Airways New Zealand submission to the Civil Aviation Authority's 2018 Nelson and Marlborough Airspace Review

**Prepared by: John Wagtendonk
Policy, Standards and Safety Improvement
Airways New Zealand**

11 January 2018

This submission requests a reduction in the size of the Nelson control zone (NS CTR) and significant changes to the Nelson control area (NS CTA).

Diagram 1 Draft NS CTA and CTR

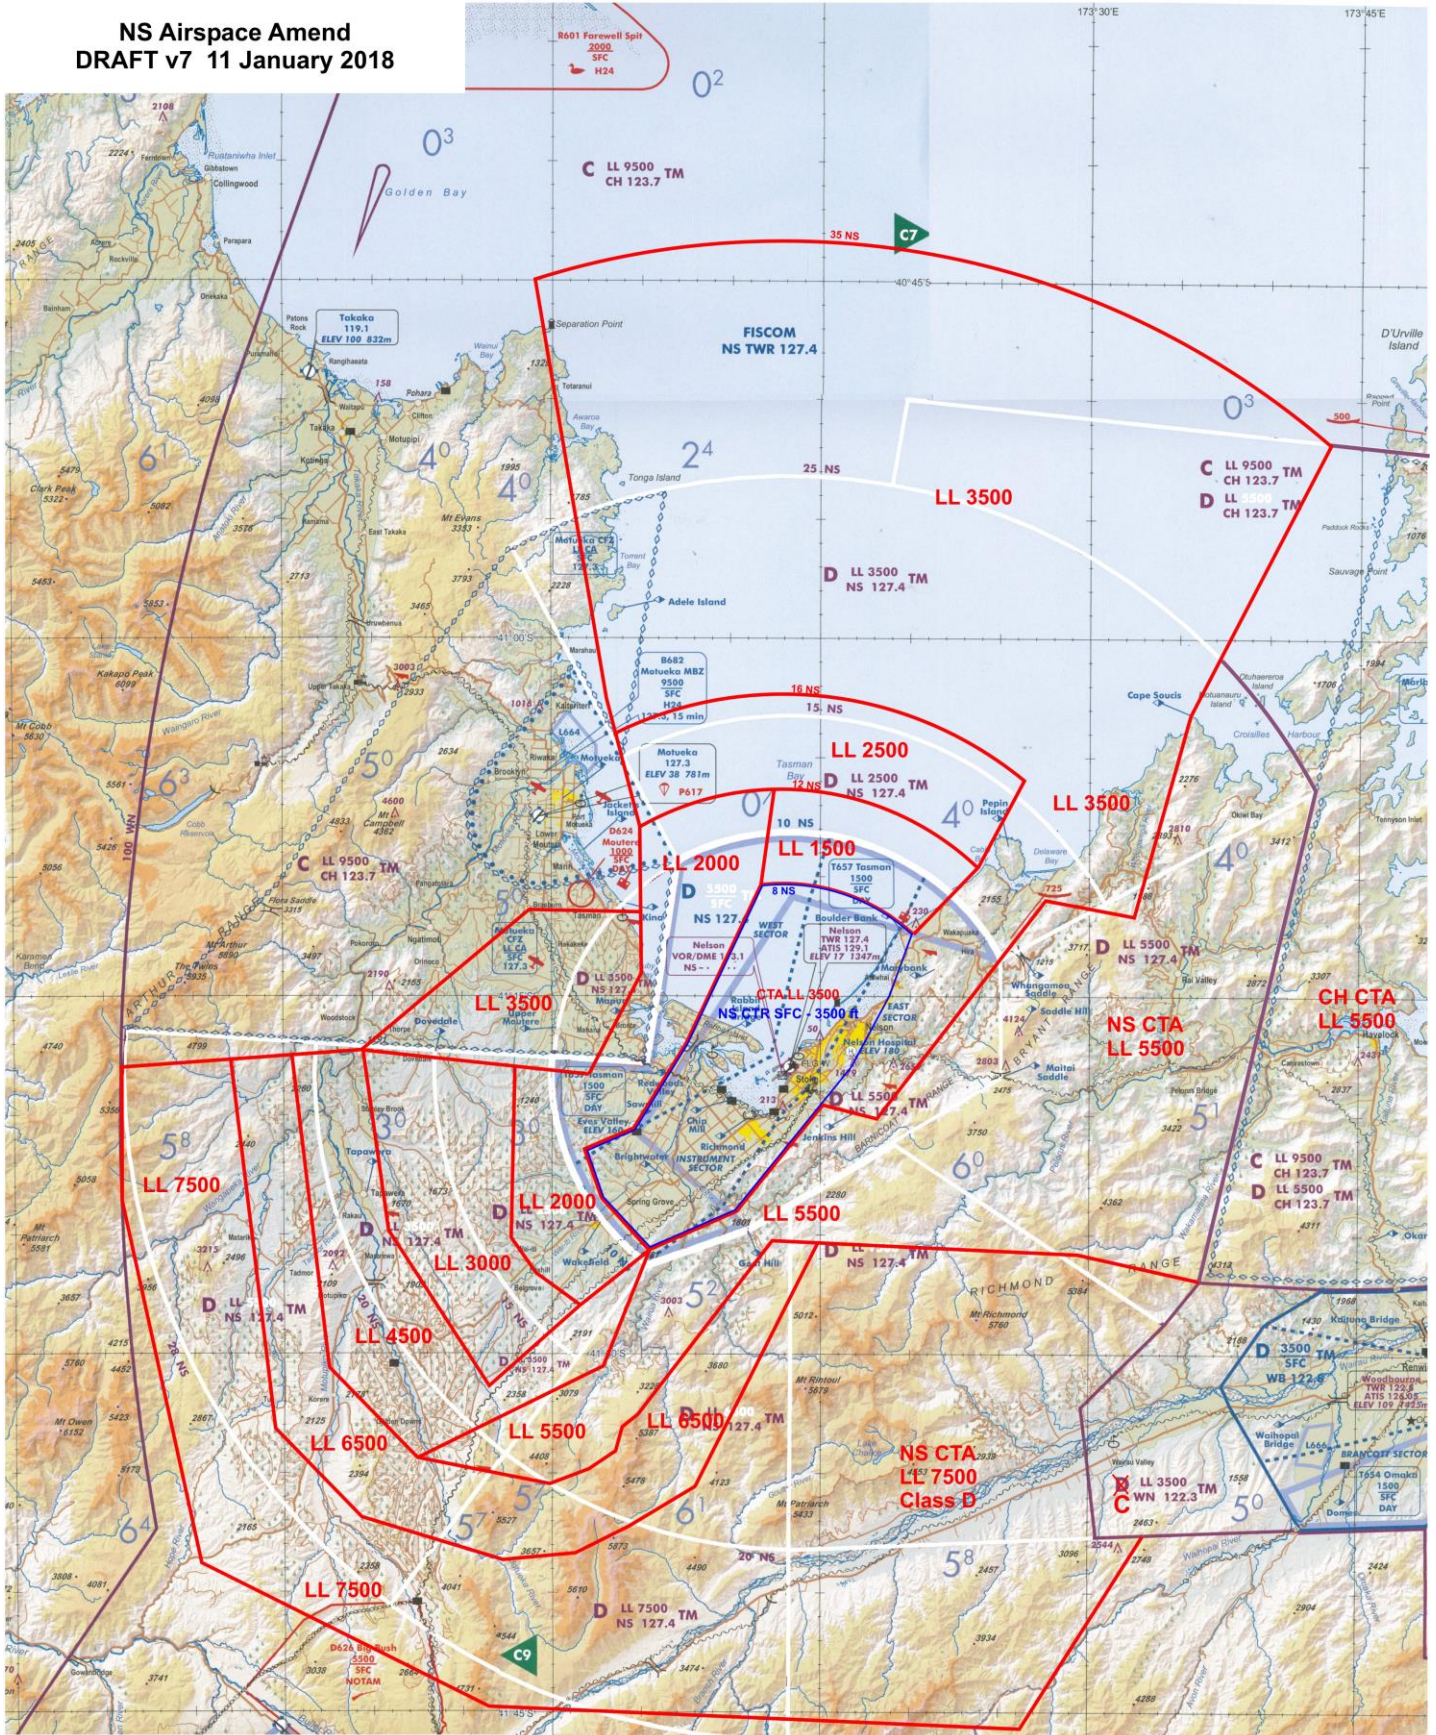
Diagram 1 below depicts the Airways proposed amended Nelson control zone (NS CTR) and Nelson control area (NS CTA). The white lines are the existing airspace boundaries that would be deleted.

- Transit lane T657: northern and western portions to be disestablished - southern portion to be amended.

Diagram 2 Close up of Draft CTR

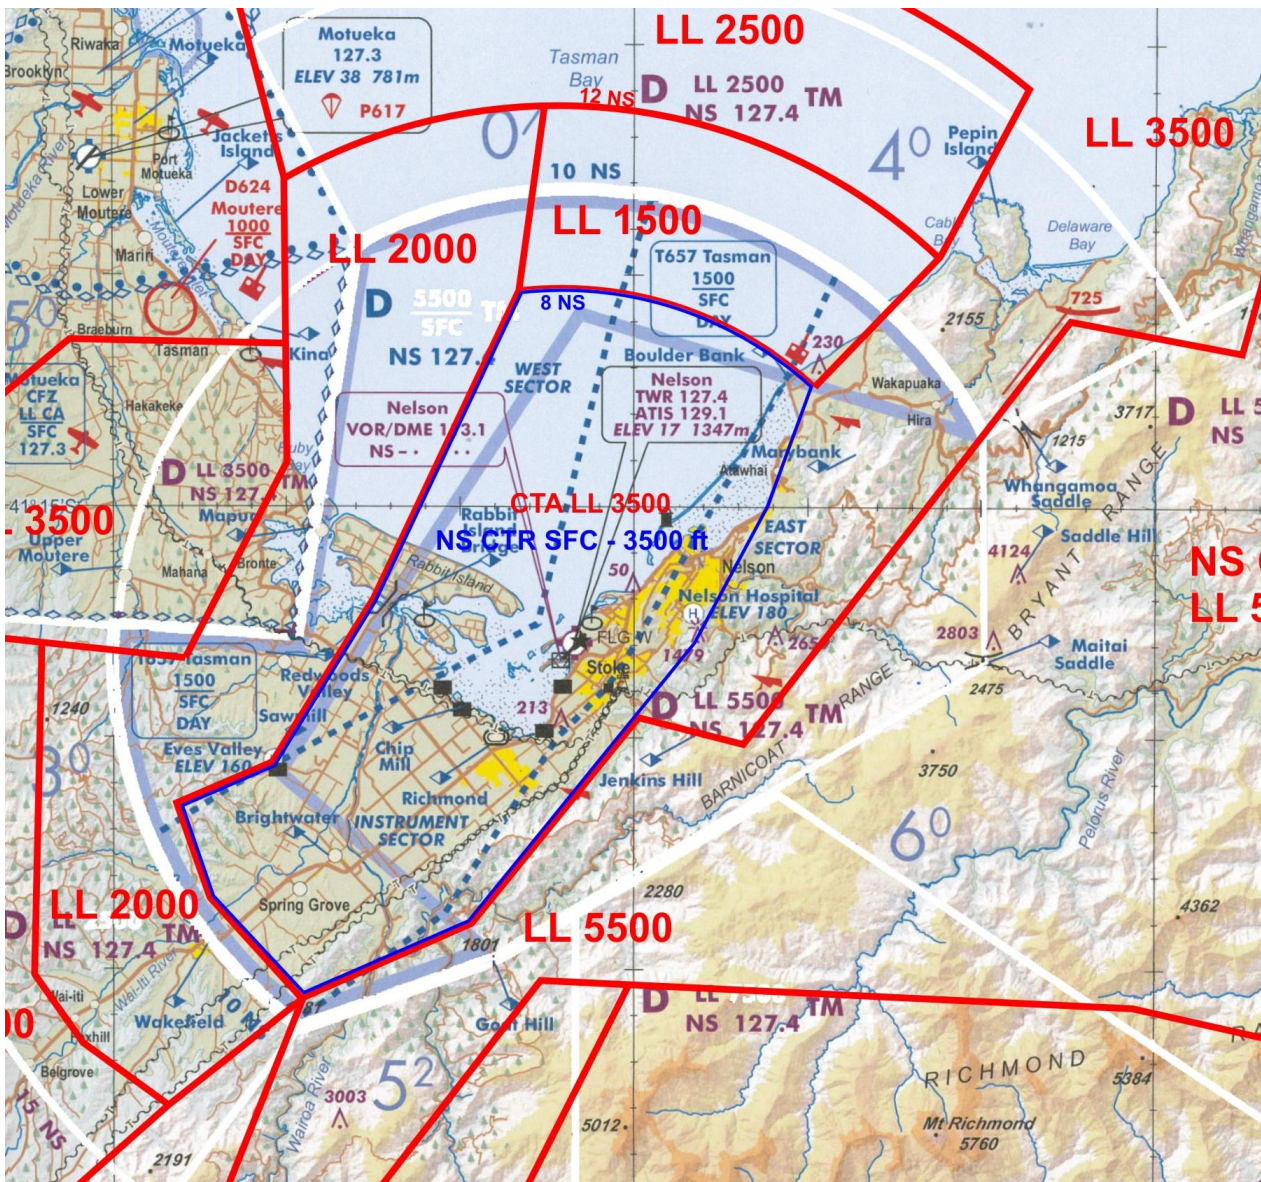
Diagram 2 below is a close up of the draft NS control zone (CTR) – the thin blue line. Note the significant reduction in the CTR to the east of Nelson airport. The eastern boundary of the draft CTR lies 2 NM to the east of the airport. This would provide sufficient protection to light aircraft operations in the non-standard circuit to the east.

The draft CTR (and the CTA) is designed to contain the VOR/DME teardrop approaches based on the aircraft flying a continuous descent profile, including during the base turn, of not shallower than 300 ft per NM to runway threshold.

The western boundary of the draft CTR provides for containment of the Cat A, B and C circling areas for the IFR approaches. Unfortunately, the western boundary can not be brought closer to lie over Rabbit Island bridge as doing that would infringe the Cat C circling area (4.2 NM radius from RWY 02/20 thresholds).

Diagram 2 depicts the existing transit lane T657. The Airways submission is that the northern and western portion of the transit lane will be disestablished but a modified transit lane will be retained in the southern portion of the CTR. Refer to Modified transit lane paragraph next page.

The instrument sector depicted on Diagram 2 will be modified slightly to correctly fit the requested CTR and approaches.

Diagram 3 detailing infringement of RNAV approach by T657

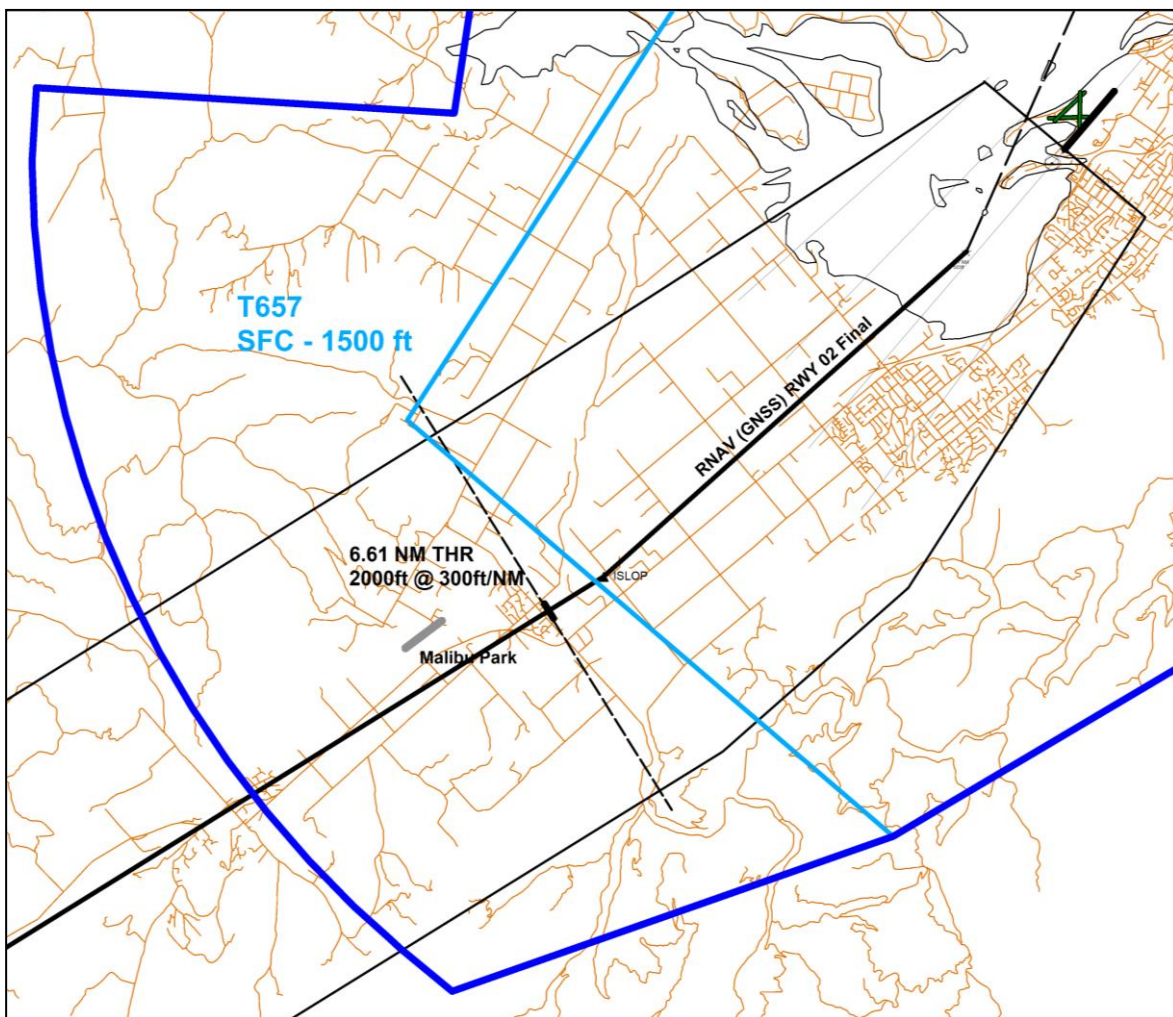
The existing transit lane T657 (SFC to 1500 ft) infringes the VOR/DME C and RNAV (GNSS) RWY 02 approaches. Diagram 3 below depicts the inbound legs of the RNAV (GNSS) RWY 02 approach along with the lateral containment fan to the left and right of the final approach track. Also marked is the point on the approach track at 6.61 NM where the airspace containment profile of 300 ft per NM from runway threshold descends through 2000 ft.

Inside 6.61 NM from the threshold, the airspace containment profile for the approach is lower than 2,000 ft and is less than the minimum 500 ft above the transit lane. Therefore, the approach is not correctly contained in regards to the transit lane – the transit lane infringes the containment of the approaches.

The same situation exists for the VOR/DME C approach.

For correct airspace containment of those approaches, T657 would need to be reduced in size – horizontally and/or vertically.

Diagram 4 detailing transit lane option 3 – inner boundary does not follow prominent geographical features

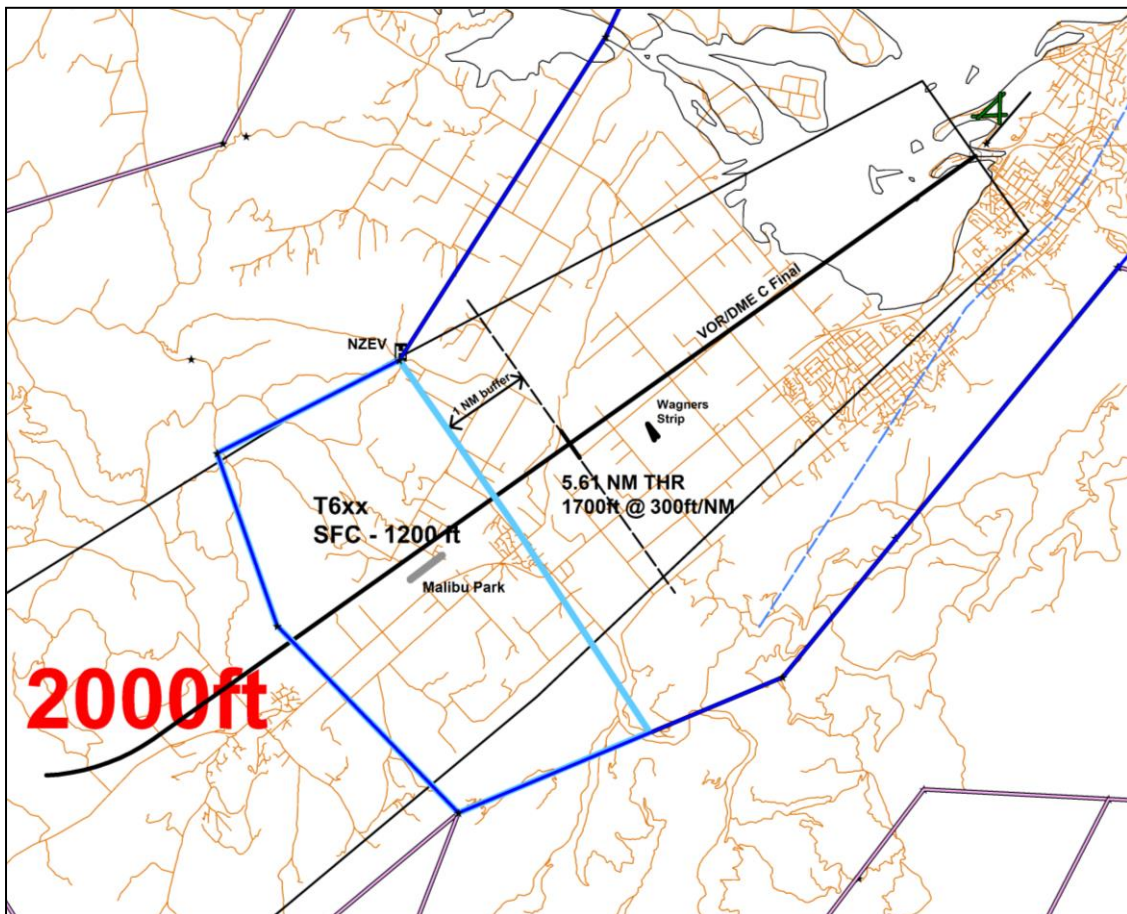
1. to retain the current boundary of T657 the upper limit would need to be reduced to 900 ft AMSL;
2. to retain the 1500 ft upper limit, the inner boundary of T657 would need to be moved west to lie 1 NM west of Brightwater, over the top of Malibu Park airfield;
3. Diagram 4 depicts an option with a 1200 ft upper limit with the inner boundary through Brightwater – note that the inner boundary does not follow prominent geographical features and therefore a 1 NM buffer needs to be applied; and
4. Diagram 5 depicts an option with a 1400 ft upper limit with the inner boundary following prominent geographical features being Eves Valley Rd, short sealed road, metalled road, Waimea West Rd, Ellis St, River Terrace Rd and Lee Valley Rd.

Diagram 5 detailing transit lane option 4 – inner boundary does follow prominent geographical features (roads)

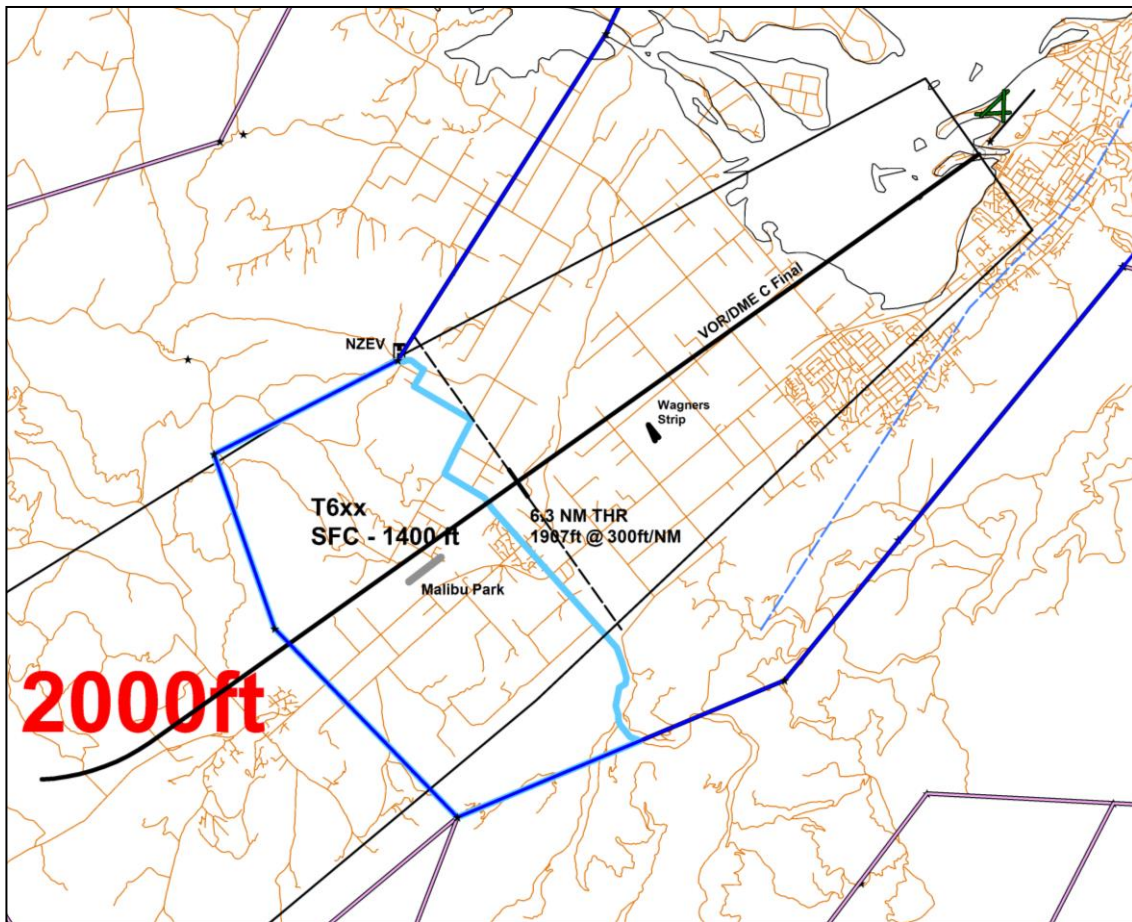
At the 20 October 2017 Airways PBN consultation meeting held at Nelson, the feedback from attendees was that option 4 should be adopted.

This option is also suitable for the RNAV approach and departures – although the departures would need to specify a slightly steeper gradient than 5% to 1900 ft to clear the 1400 ft upper limit of the transit lane.

Operators said that the specified roads for the inner boundary were easy to see.

In light of the feedback, the Airways submission is for the retention of the southern portion of T657 with modified boundary as per option 4/Diagram 5 and upper limit lowered to 1400 ft AMSL.

Diagram 5 Google Earth image showing the location of Eves Valley heliport (NZEV), the draft CTR (blue line) and the inner boundary of transit lane option 4 (light blue line)

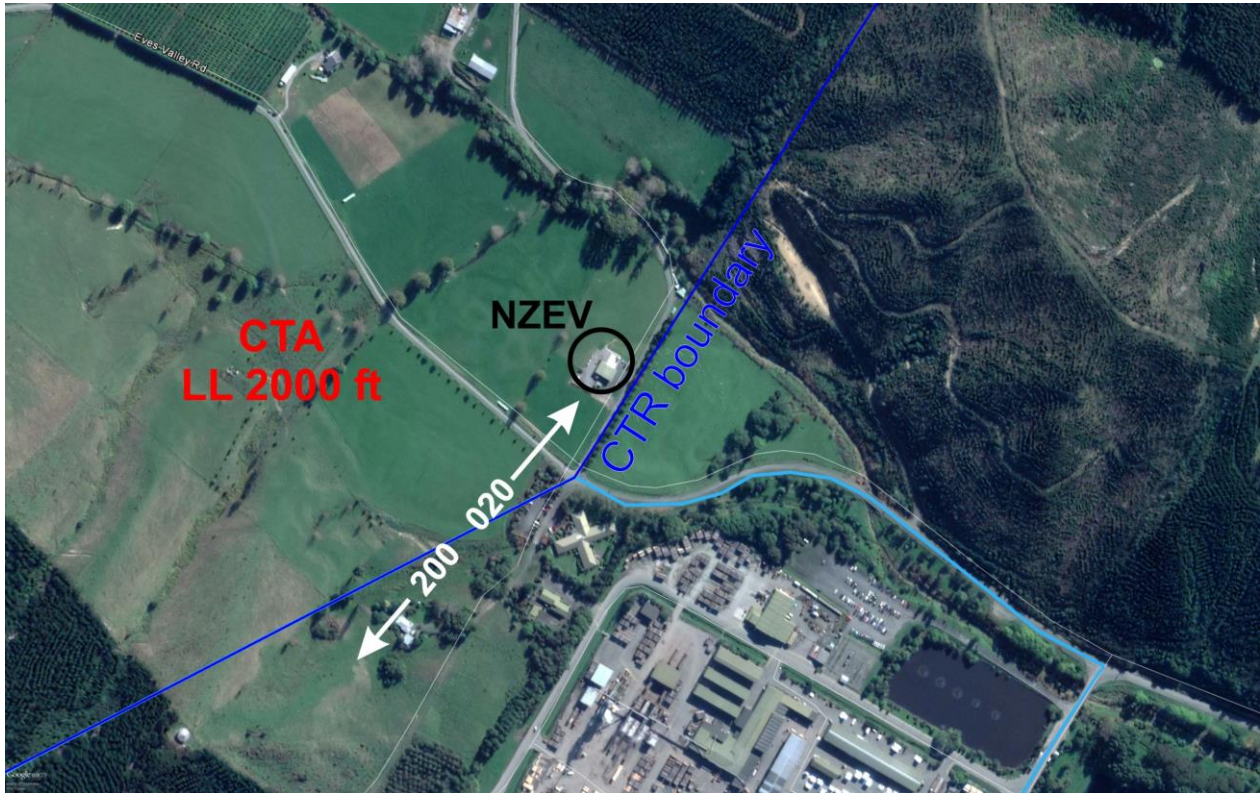
As depicted on the Google Earth image below, the Eves Valley heliport (NZEV) is just outside the requested CTR.

If the requested CTR is adopted, Airways suggests to the operator that the extent of the NZEV APCH/DEP Sector should be reviewed – the current 200° 020° track goes inside the CTR.

Diagram 7 Draft CTA to the north

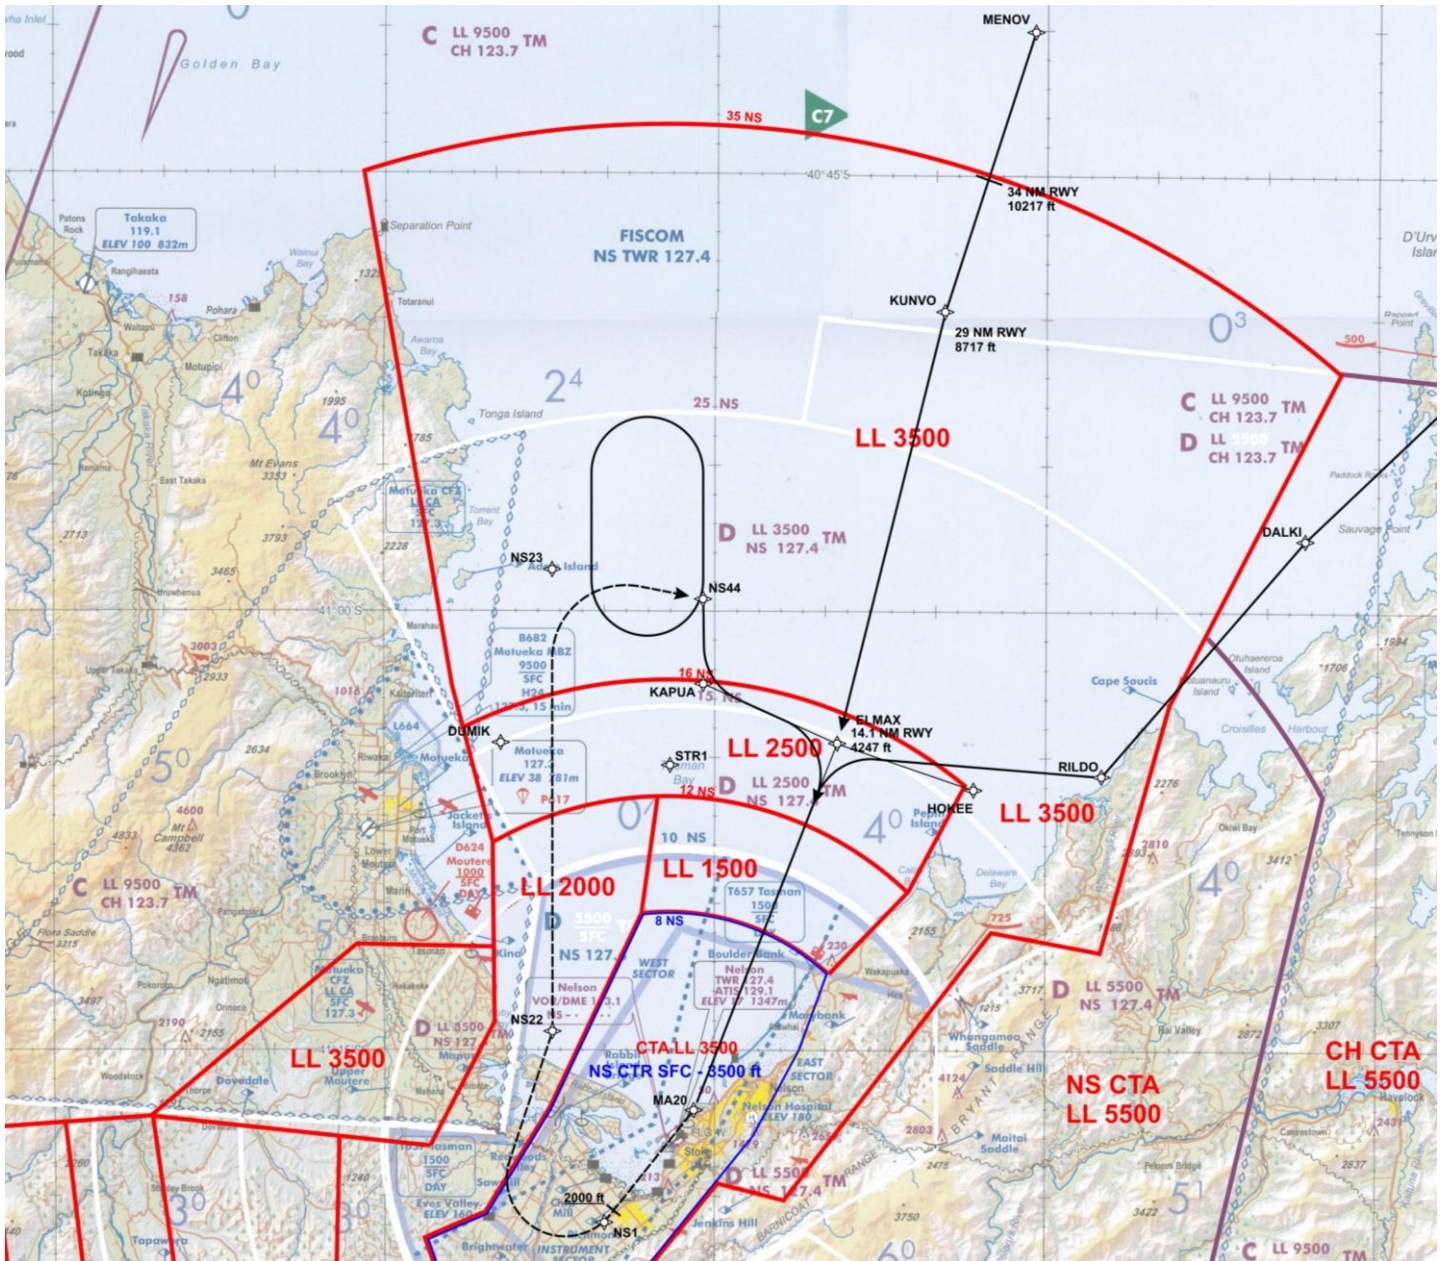
The extensive CTA LL 3500 ft to the north of Nelson is required to provide airspace containment for the planned new missed approach holding pattern (west of current location) and the holding pattern at ELMAX. CTA below 10,000 ft is also needed out to 35 NM NS to contain the descent profile of the new PBN arrival to RWY 20 via MENOV and KUNVO waypoints.
